From: Alan Wang
To: Jared Wermiel
Date: Fri, Jan 17, 2003 9:49 AM
Subject: Re: 1/22 meeting on GE Revised Chapter 1 of CPPU Topical

New Chapter 1 for NEDC-33004P Rev 3.doc
2003 9:47 AM
MESSAGE

1.0 INTRODUCTION

Figure 1-1. Typical CPPU-Based Power Uprate Power/Flow Map

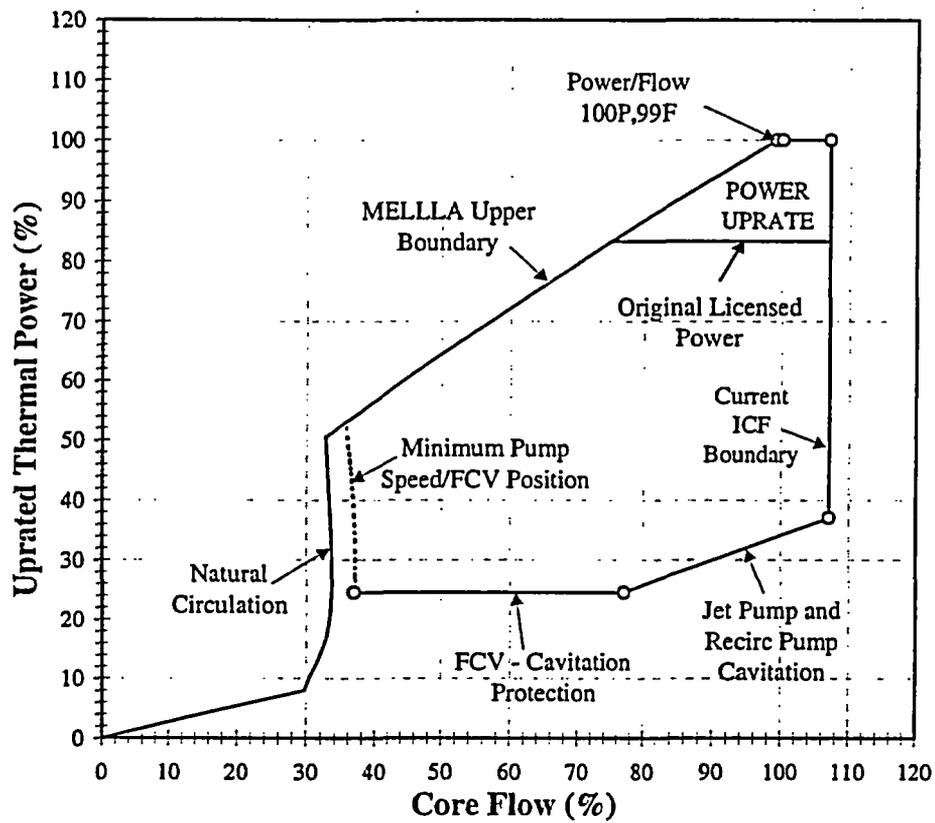
Comment: Page: 11
 GE-6 JFH Opened Up Text Boxes
